# UNITED STATES PATENT AND TRADEMARK OFFICE

APPLICATION NO.	FILING DATE	FIRST NAMED INVENTOR	ATTORNEY DOCKET NO.	CONFIRMATION NO.
10/664,108	09/17/2003	Timothy W. Sheriff	17904-294811	4745

<b>Office Action Summary</b>	<b>Application No.</b>	<b>Applicant(s)</b>	
	10/664,108	SHERIFF, TIMOTHY W.	
	<b>Examiner</b>	<b>Art Unit</b>	
	Debra Wolfe	3725

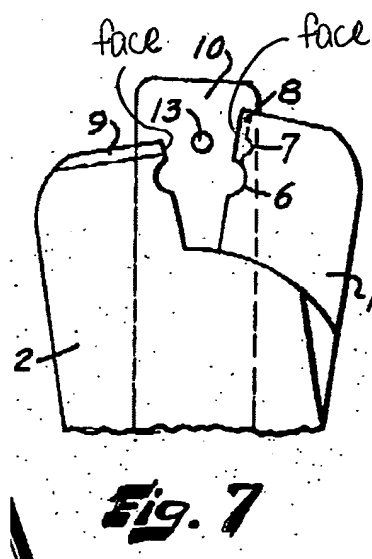
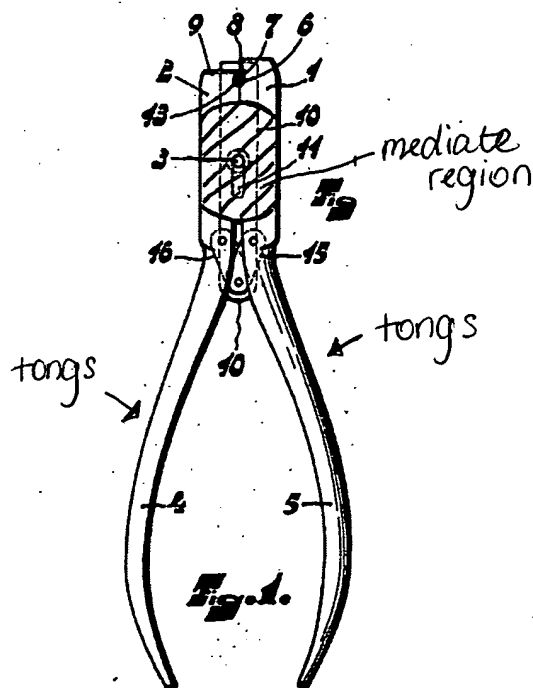
Claims 1-7 are rejected under 35 U.S.C. 102(b) as being anticipated by Knoester (U.S. Patent # 2,824,583). Knoester discloses a loop or eye forming pliers having a first and second member (tongs, See col. 2, line 16), each having a jaw (1, 2) with a flat face (See FIG 7) at a

distal end and a relief (cavities 6) located between the face (See FIG 7) and mediate region (See FIG 1) thereby forming a recess when the first and second members (tongs) are assembled with the faces opposing each other, a handle (handles 4, 5) and a mediate region (See FIG 1); a connecting means (common pivot 3) for securing the first and second members together at the mediate region and for preventing pivoting movement between the first and second members while locating the jaws on the same side of the connecting means such that the jaws are opposed to each other and free to move towards and away from each other (See FIG 1); a link (plate 10) attached to the mediate region (See FIG 1) of the first and second members (tongs) having a post (core pin 13) projecting from the link (plate 10) and projecting into the recess formed by the reliefs (cavities 6) of the jaws (1, 2).

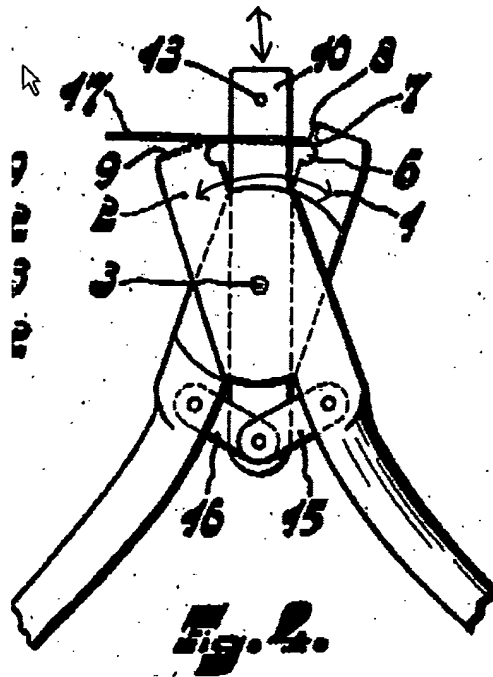
As it appears in Knoester the link (plate 10) is loosely secured to the mediate region (See FIG 1) of the first and second members (tongs) to permit limited movement of the post within the recess and the post (core pin 13) is free to move towards and away from the connecting means (common pivot 3) through a slot (11) on the link (plate 10). Figure 4 of Knoester appears to show the jaws (1, 2) having a closing arc and the post (core pin 13) having a limited movement generally perpendicular to the closing arc of the jaws (1, 2) (See arrows of FIG 4).
